ADDRESS : 41 RAINMAKER ST SUBDIV: SWEETWATER 71LOTS
 CONTRACTOR : ATLANTIC CONSTRUCTION PHONE : (910) 938-9053
 OWNER : DIVERSIFIELD INVESTORS INC PHONE :
 PARCEL : 01-0544- - -0004- -33-
 APPL NUMBER: 17-50042844 CP NEW RESIDENTIAL (SFD)
 DIRECTIONS : T/S: 11/30/2017 09:46 AM BPETRICH --
 41 RAINMAKER STREET LINDEN 28356
 SWEETWATER #25

PERMIT: CPSF 00 CP * SFD

Re: 1408707

Atlantic Const.JAX. Christian Plan

Job 1408707	Truss A02	Truss Type Common	Qty 5	Ply 1	Atlantic Const.JAX, Christian Plan	1 UNIT YF	I33819564
----------------	--------------	----------------------	----------	----------	------------------------------------	-----------	-----------

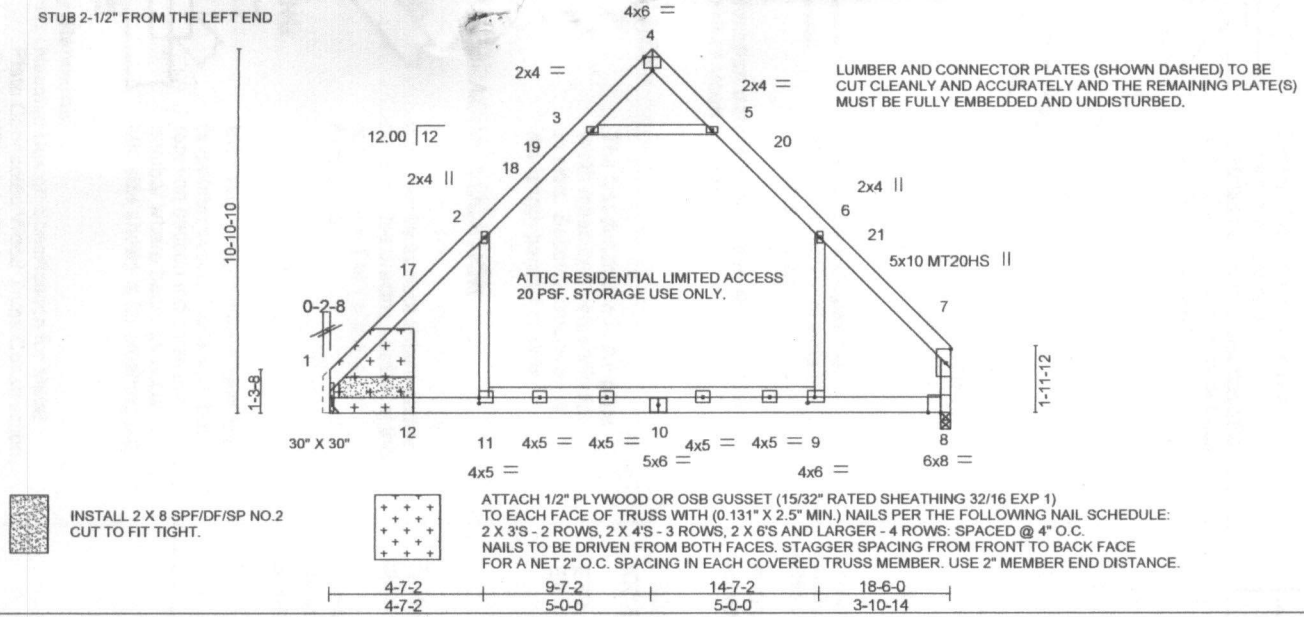
B111 01	5/18/18	JH	R*BLDG SLAB INSP/TEMP SVC POLE TIME: 17:00 VRU #: 003129319
	5/18/18	AP	T/S: 05/17/2018 12:57 PM DJOHNSON -----
E207 01	6/01/18	JH	R*ELEC TEMP SERVICE POLE TIME: 17:00 VRU #: 003134392
	6/01/18	AP	T/S: 05/31/2018 01:42 PM BPETRICH ----- MOVING TPOLE FROM ADJACENT LOT TO THIS LOT
R425 01	6/20/18	JH	FOUR TRADE ROUGH IN TIME: 17:00 VRU #: 003142221
	6/20/18	DP	T/S: 06/19/2018 01:59 PM BPETRICH ----- 1) Missing windows on front of house to left of front door & To right of fire box in living room. 2) Fire caulk dryer wire @ top plate in garage. 3) Tighten all loose anchor bolts in garage. 4) Missing anchor bolts each side of door in garage, back left corner of kitchen, back door & front door. 5) Anchor all interior load bearing walls per code. 6) Need engineer letter for trusses not bearing in there hangers in kitchen & front left bedroom. 7) Missing nails in floor truss hangers in kitchen & half bath. 8) Nail & HURRICANE strap all 2ply trusses per truss documents. 9) Nail osb on back wall in master bedroom. 10) Insulation baffles. 11) Fire block top of chase in hall closet. 11) 3' head of water on drain line test. 12) Missin Chase for duct in front left bedroom. 13) Need repair letter

TYP/SQ	REQUESTED COMPLETED	INSP RESULT	DESCRIPTION RESULTS/COMMENTS
			for broken truss web in front left bedroom.14)Nail house wrap per installation instructions. DO NOT SIDE OR INSULATE
P307 01	<u>7-11-18</u>	TI <i>APJ</i>	R*PLUMB WATER CONNECTION TIME: 17:00 VRU #: 003149887 T/S: 07/09/2018 04:09 PM LLUCAS -----
R425 02	<u>7-11-18</u>	TI <i>APJ</i>	FOUR TRADE ROUGH IN TIME: 17:00 VRU #: 003149879 T/S: 07/09/2018 04:09 PM LLUCAS -----
